SAND2006-0312

Technical Review of Proposed Changes in Montana Water Quality Standards for Coal Bed Natural Gas Produced Water

**TECHNICAL REVIEW OF PROPOSED CHANGES IN
MONTANA WATER QUALITY STANDARDS FOR
COAL BED NATURAL GAS PRODUCED WATER**

Figure 1. General Geologic Cross Section of the Powder River Basin (Rice 2000)

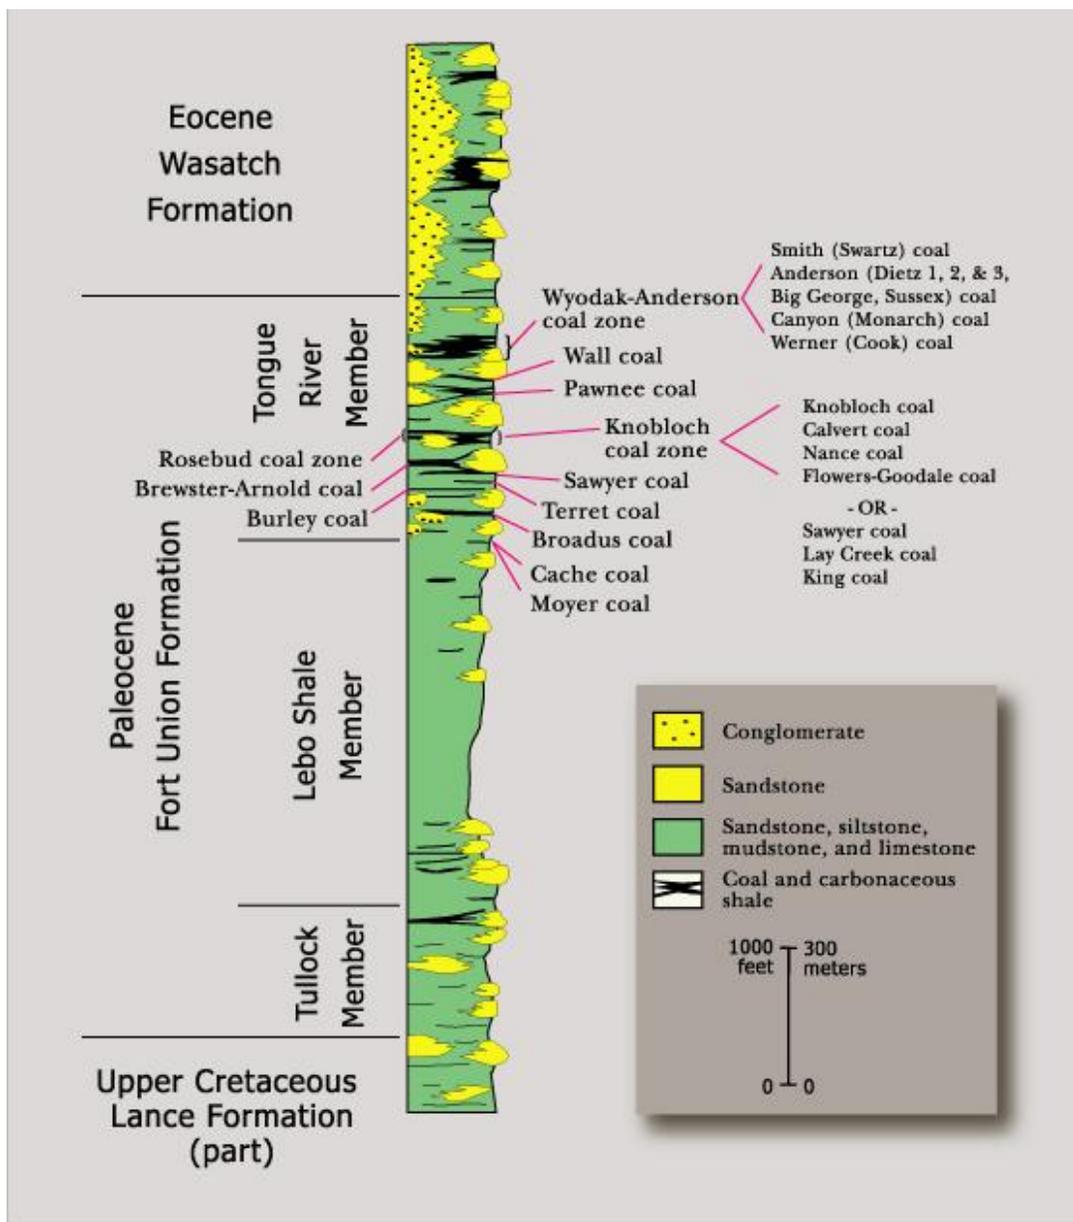
The Fort Union Formation (Rice et al 2001; Arthur et al 2005, Pritchett 2002) as shown in Figure 1 and presented in Table 2, contains all the water producing coal beds in the Montana PRB (MBMG 2001). In the Montana portion of the PRB the bulk of the coals are confined to the Tongue River Member of the Fort Union Formation. The Lobo and Tullock members are predominantly shale and shaley-sand (McLellan et al, 1990).

Figure 2. Soil Infiltration Impact based on SAR and Salinity (modified from Ayers and Westcott) (CBM Produced Water and Powder River Characteristics from USGS)

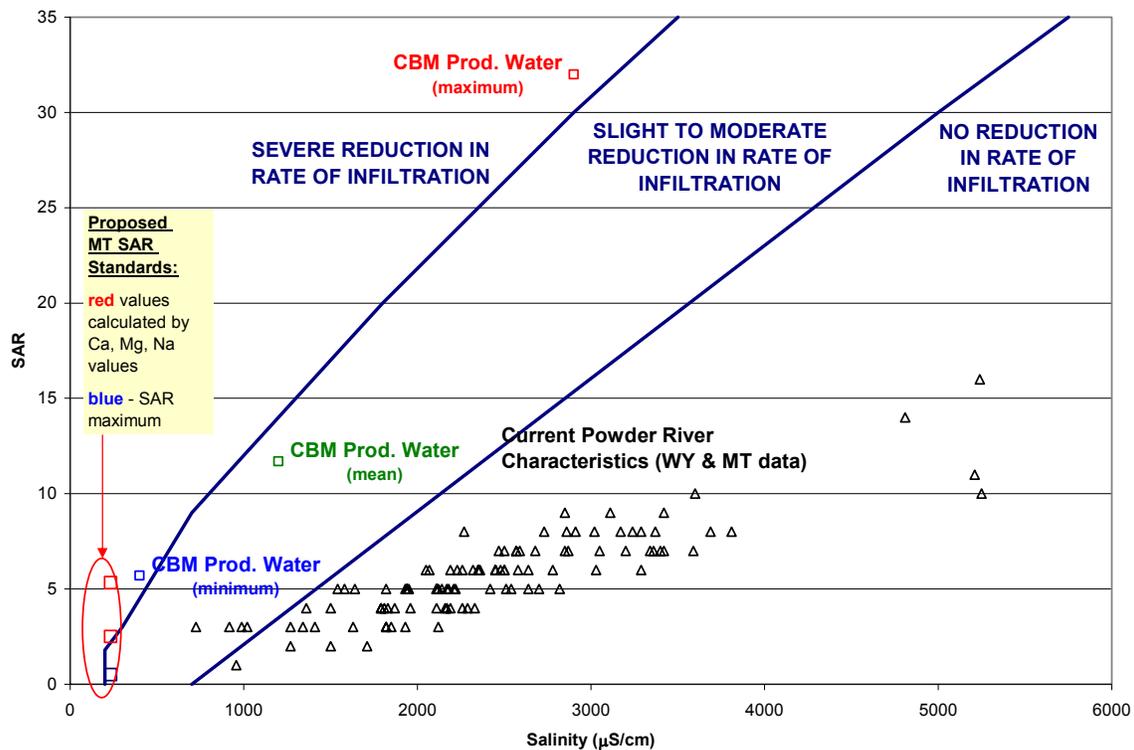
Treating the water to the required SAR and EC will negatively impact water infiltration in soils and negatively impact irrigation. As identified in Table 1, irrigation water quality with an EC of 500 to 3000 µS/cm can be appropriately used. As shown in Figure 2, treating the water to the identified SAR and EC values will create a water quality with very poor

infiltration characteristics, and therefore negatively impact irrigation efficiency. The information in Figures 2 and 3 suggest that significantly higher values of SAR and EC (a factor of ten or more) would be much more beneficial to irrigation efficiency without negatively impacting crop yields for most of the common crops in this region.
